**Supplemental Material
Received at the Meetings of
City Council
Redevelopment Agency
Housing Authority
Financing Authority
for
January 16, 2007**

Item 22: Fulton Avenue Development Project

**REVISED ERRATA
FULTON AVENUE DEVELOPMENT PROJECT (P06-012).**

**NOTICE OF ERRATA –MITIGATION MONITORING PLAN, FINDINGS OF FACT,
AND CONDITIONS OF APPROVAL
FOR THE FULTON AVENUE DEVELOPMENT PROJECT (P06-012).**

Revised Mitigation Monitoring Plan Pages 5-24 and 5-25

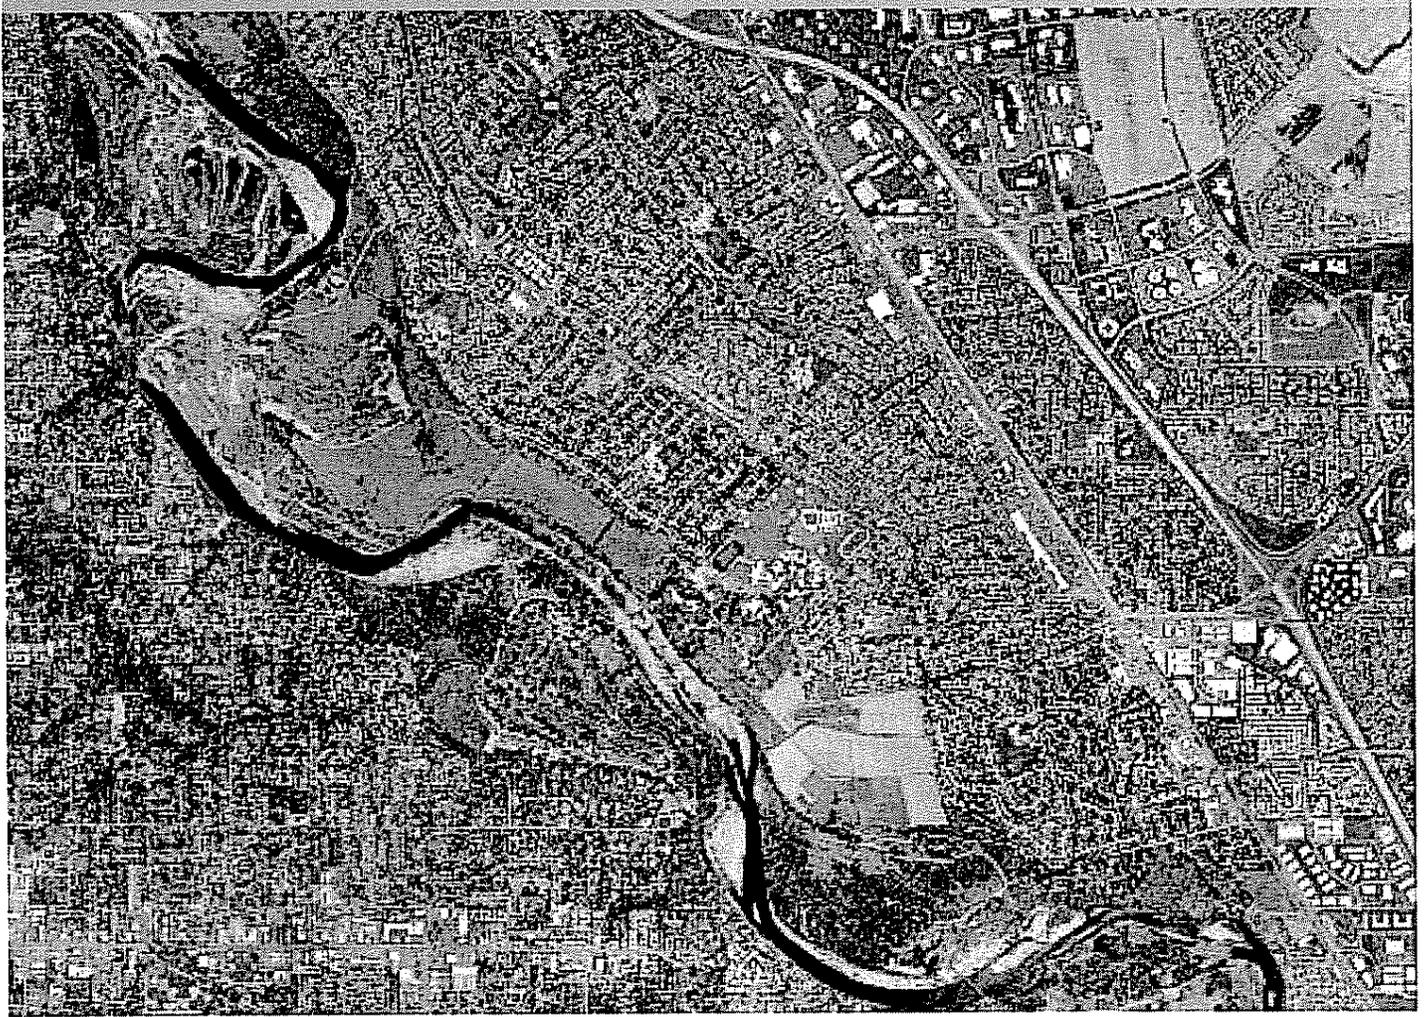
In addition, for both Mitigation Measure 3.4-1D and 3.4-6D, under the "Implementing Party" column (fourth column from the left), Pages 5-24 and 5-25 of the Mitigation Monitoring Plan are hereby revised so that the word "Developer" is replaced by the word "City."

Attachment 1 includes copies of Pages 5-24 and 5-25 of the Mitigation Monitoring Plan indicating the above revisions (~~strikethrough~~ = deleted text; double underline = added text).

<p>3.6-3D inadequate storage at Business 80 westbound off-ramp at Fulton Avenue.</p>	<p>MM 3.6-3D Implementation of MM 3.6-1D.</p>	<p>MM 3.6-4D The applicant shall coordinate with Caltrans to install a traffic signal shall be installed, in coordination with Caltrans, at the intersection of Fulton Avenue and the Business 80 westbound ramps. Installing a traffic signal will improve the intersection operation from LOS 'F' to LOS 'D' or better.</p>	<p>See MM 3.6-1.</p> <p>Developer/City</p>	<p>See MM 3.6-1.</p> <p>Prior to issuance of Certificates of Occupancy</p>	<p>See MM 3.6-1.</p> <p>City of Sacramento; Development Services Department Caltrans</p>	
<p>3.6-4D Cumulative, unacceptable levels of service at the intersection of Fulton Avenue and Business 80 westbound ramps (westbound approach) during the AM, PM, and Saturday peak hours. Also, at this intersection the MUTCD peak hour signal warrant is met during all of the study peak hours.</p>	<p>MM 3.6-4D The applicant shall coordinate with Caltrans to install a traffic signal shall be installed, in coordination with Caltrans, at the intersection of Fulton Avenue and the Business 80 westbound ramps. Installing a traffic signal will improve the intersection operation from LOS 'F' to LOS 'D' or better.</p>	<p>See MM 3.6-1.</p> <p>Developer/City</p>	<p>See MM 3.6-1.</p> <p>Prior to issuance of Certificates of Occupancy</p>	<p>See MM 3.6-1.</p> <p>City of Sacramento; Development Services Department Caltrans</p>
